# MANDATORY REFERRAL NO. 2025004 – CARROLL AVENUE SEPARATED BIKE LANES

This is a Mandatory Referral review for the Montgomery County Department of Transportation proposal to construct separated bike lanes on Carroll Avenue between Piney Branch Road and Merrimac Drive.

No. MR2025004

Figure 7: Curb Ramps Missing Tactile Warning Surfaces Between Merrimac Drive and University Boulevard

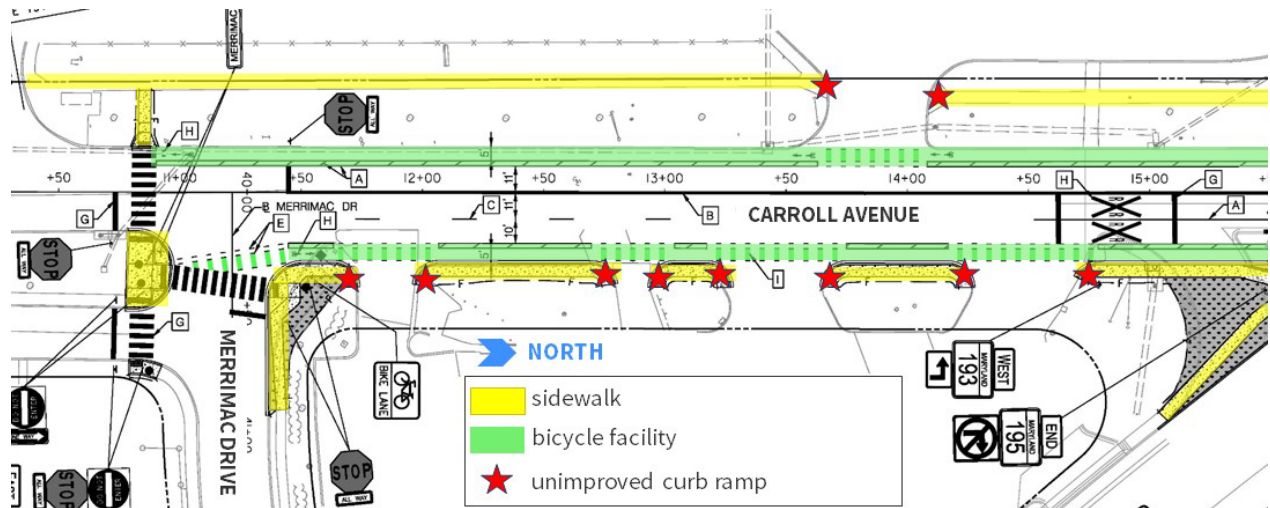
The *Pedestrian Master Plan* recommends crosswalks be provided at all intersection legs, and the *Complete Streets Design Guide* states that “the preferred standard is two perpendicular curb ramps per corner, each aligning with desired paths of travel.” Figure 7 and Figure 8 show specific curb ramps that are missing tactile warning surfaces as red stars. These include the following locations: curb ramps at Stations 13+50, 14+00, 34+50, 35+00, 38+00, 38+50 and the east side of Carroll Avenue between University Boulevard and Merrimac Drive.

1. **Replace proposed continental crosswalks with ladder crosswalks, provide tactile warning surfaces in all curb ramps, and provide directional crosswalks at all legs of an intersection.**

Figure 10: Applicant-Proposed Configuration of Merrimac Drive and Carroll Avenue Intersection

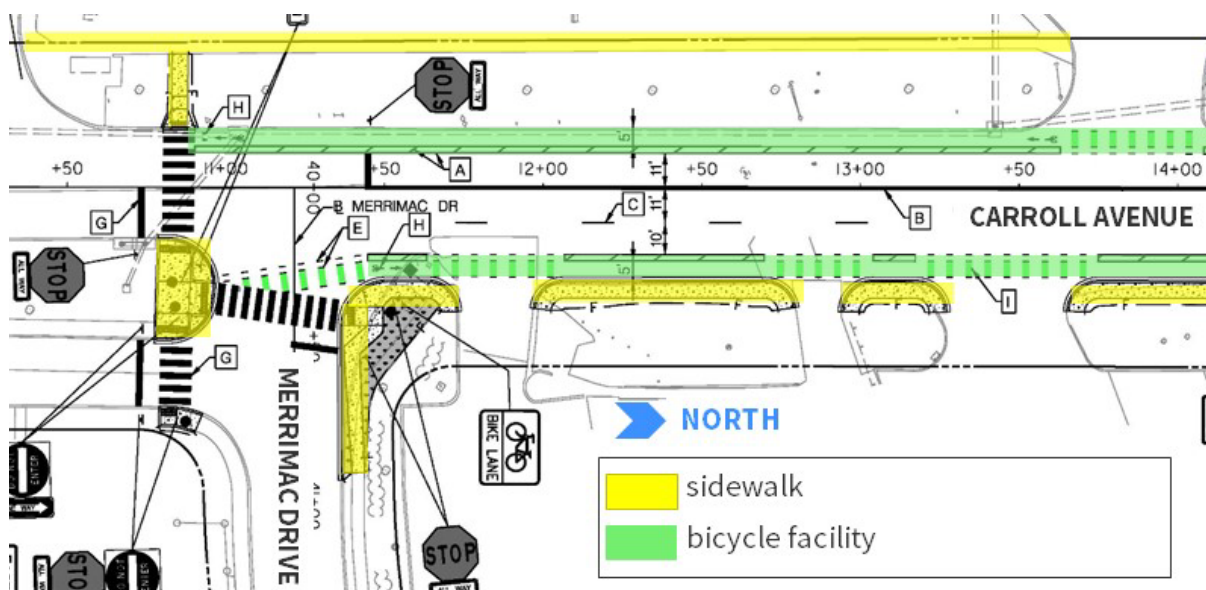
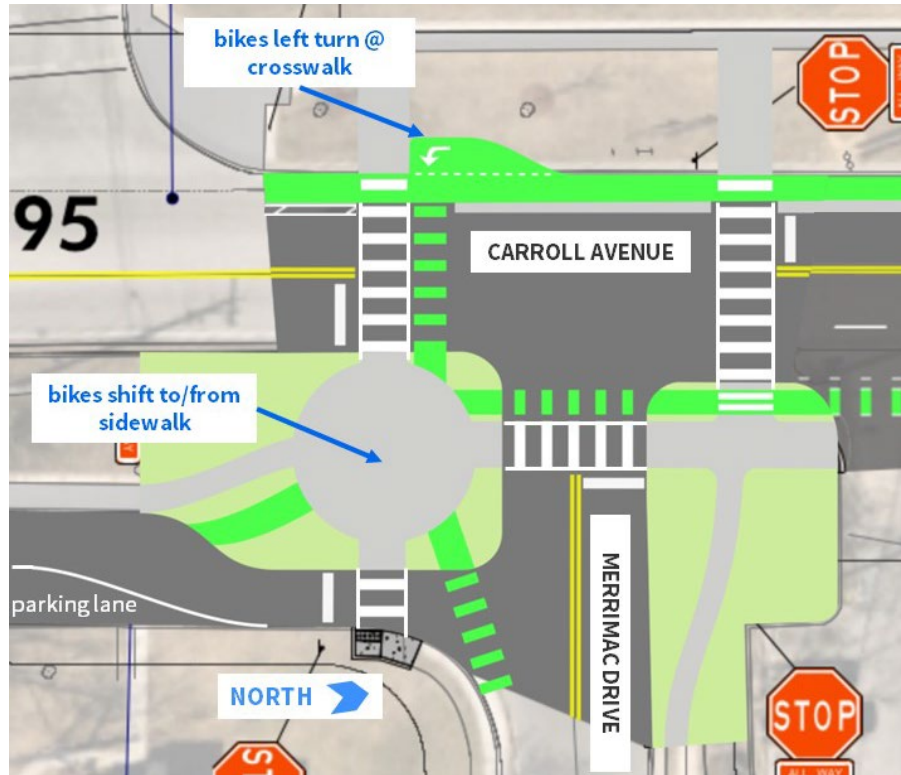
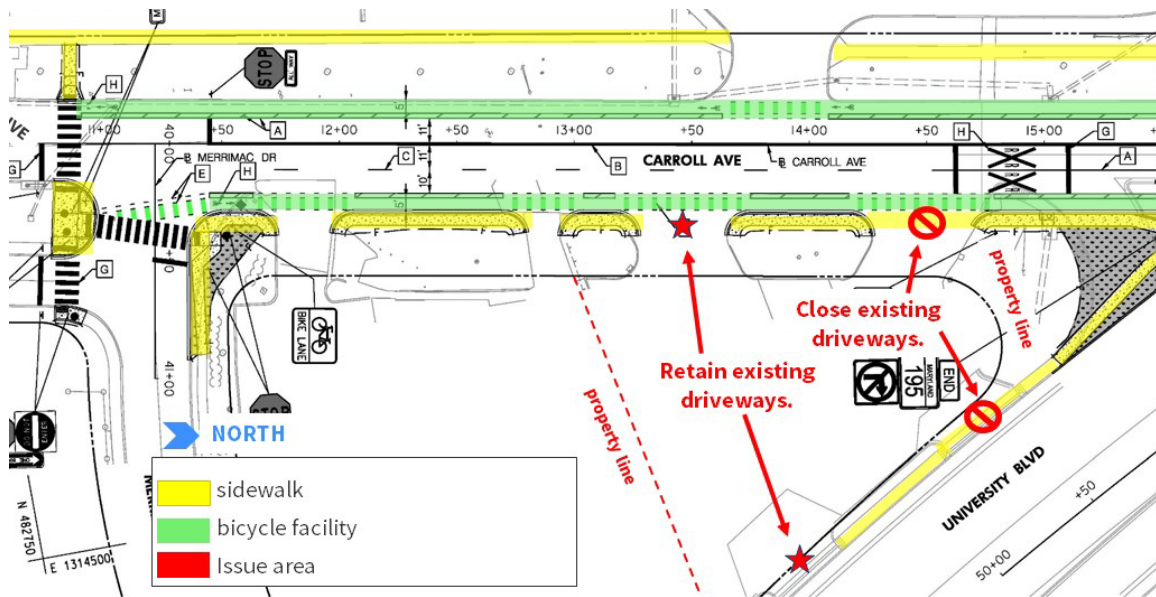
- 3. Reconfigure the intersection and crossings at Merrimac Drive and Carroll Avenue to improve bicycle and pedestrian safety, visibility, and connectivity.** Figure 10 shows the Applicant’s proposed design for this intersection. As illustrated in Figure 11, Staff recommend adding a bicycle turning box to allow cyclists riding southbound on Carroll Avenue to safely turn left onto Merrimac Drive. Staff also recommend extending the median between Carroll Avenue and the service road to provide more space for cyclists and pedestrians and clear sight lines for vehicles. This also ensures that vehicles turning left from the service road onto Merrimac Drive enter the road further behind the stop bar at the Merrimac Drive/Carroll Avenue intersection. Finally, per the *Pedestrian Master Plan (2023)* and “Recommendation 1” in this report, the Applicant should construct an additional ladder-style pedestrian crossing over Carroll Avenue on the north side of Merrimac Drive and reconfigure all other crossings to be as perpendicular as possible.

Figure 12: Falcon Fuel Driveways and Closure Recommendations

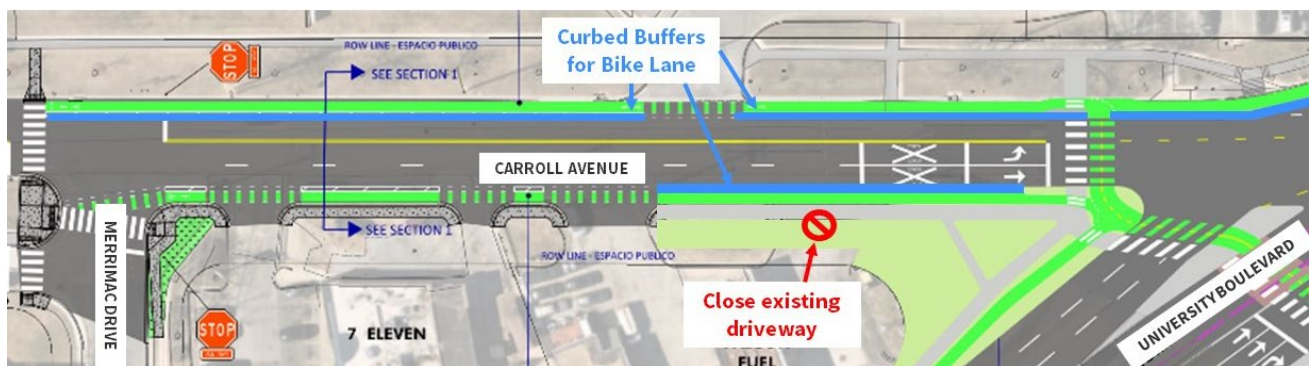
4. **Close the two existing driveway curb cuts to the Falcon Fuel gas station that are closest to University Boulevard.** The *Complete Streets Design Guide* recommends that “reducing or consolidating driveways can help create a pedestrian and bicycle-oriented environment with continuous sidewalks and bikeways, street trees, lighting, and on-street parking.” As shown in Figure 12, the existing gas station at 925 University Blvd E, Silver Spring, MD 20903 currently has four curb cuts, two of which are within 100 feet of the University Boulevard and Carroll Avenue intersection. Given that the proposed project will remove the existing slip-lane for right turns from Carroll Avenue onto University Boulevard and divert right turning traffic onto Merrimac Drive, it’s likely that drivers use the gas station curb cuts as a cut-through from northbound Carroll Avenue to eastbound University Boulevard. To reduce this behavior and reduce conflict points with pedestrians and cyclists on Carroll Avenue, the Applicant should work with the property owner of Falcon Fuel to close two of the four curb cuts.

Figure 14: Proposed Configuration of University Boulevard/Carroll Avenue Intersection with Bicycle Movements

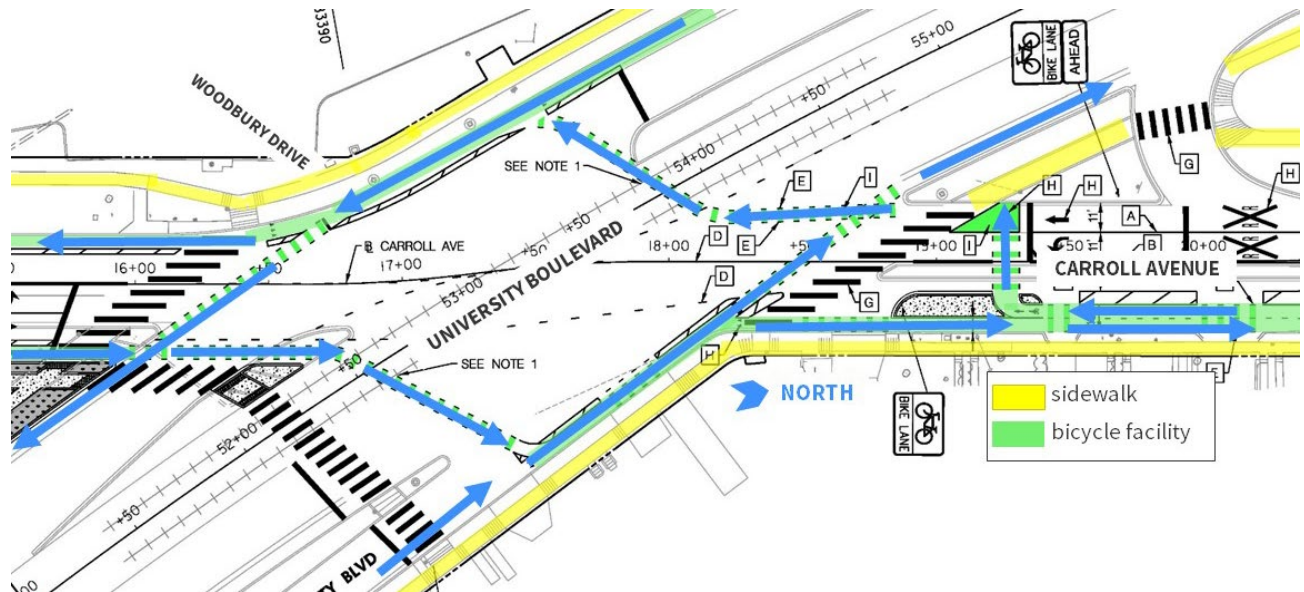
- 6. Consider constructing two-way, protected bicycle crossings across University Boulevard to reduce bicycle travel time and extend medians to improve safety.** The proposed design will construct one-way crossings in the direction of vehicle traffic to connect Carroll Avenue across University Boulevard, shown in Figure 14. With such a large, signalized intersection, bicyclists will have to complete two or three crossings to make left turns.

Providing two-way, protected crossings would reduce the distance that cyclists must travel while improving wayfinding and visibility. Figure 15 shows an existing intersection in Antwerp, Belgium that includes a median-running light rail line with two-way, protected bicycle crossings. Figure 16 shows a possible, two-way crossing configuration for the Carroll Avenue and University Boulevard intersection that involves extending curbed medians and a barrier for the University Boulevard Service Road on the northeast side of the intersection (shown in the bottom left corner in Figure 16). In addition to two-way crossings, the section of bike lanes on the northeast corner of the intersection should be made two-way, shown with red arrows in Figure 16. This will create the shortest and safest paths for cyclists and eliminate any wrong-way movements in the bike lane.

Figure 17: Recommended Curb Extension with Sidewalk Access at Piney Branch Road and Carroll Avenue

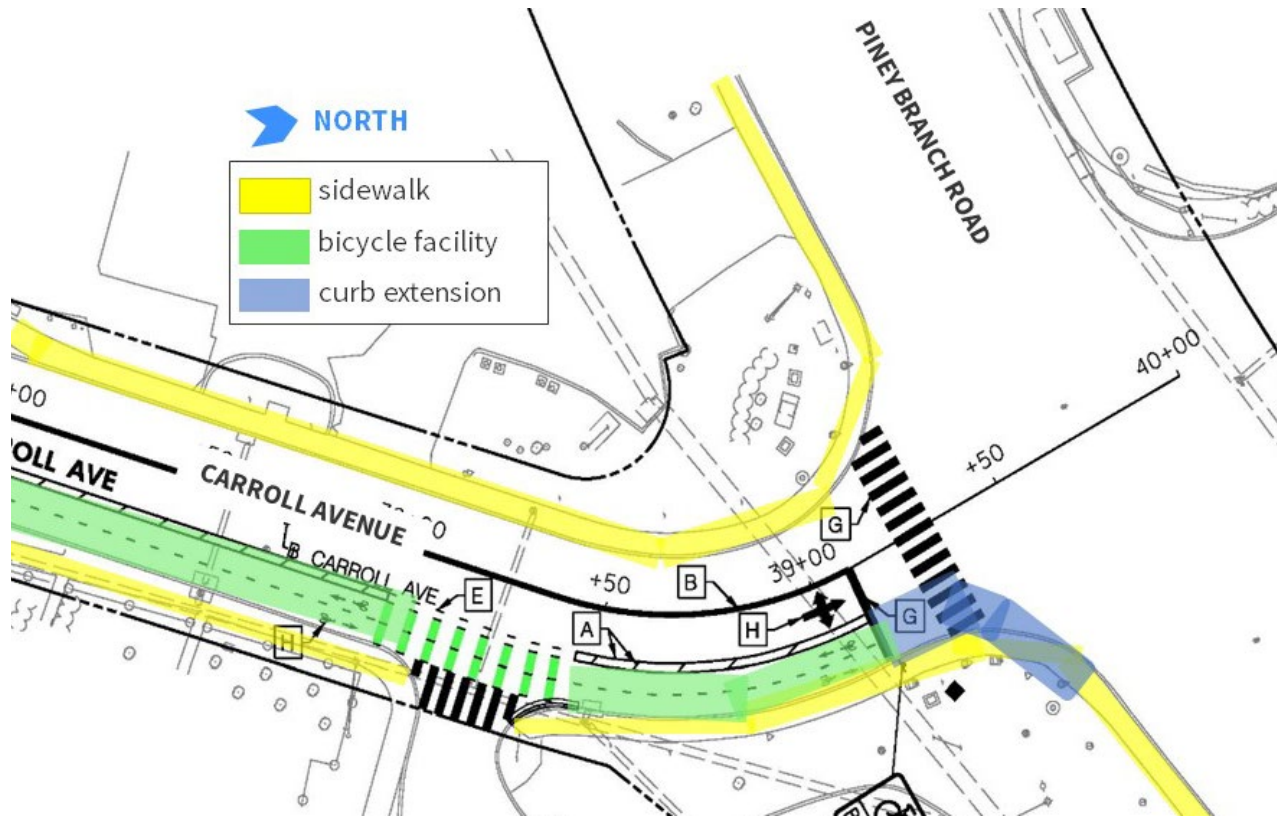
7. **Construct a curb extension at the southeast corner of Piney Branch Road and Carroll Avenue, at Station 39+00, to improve how the two-way separated bike lanes transition to and from the sidewalk.** Since there are no existing bicycle facilities on Piney Branch Road, bicyclists will

need to transition either to the roadway or the sidewalk. In addition, vehicles turning right from Carroll Avenue onto Piney Branch Road may encroach into the bicycle lane if there is no physical barrier preventing that movement. A curb extension with sidewalk access, shown in blue in Figure 17, would provide a solution to both challenges.
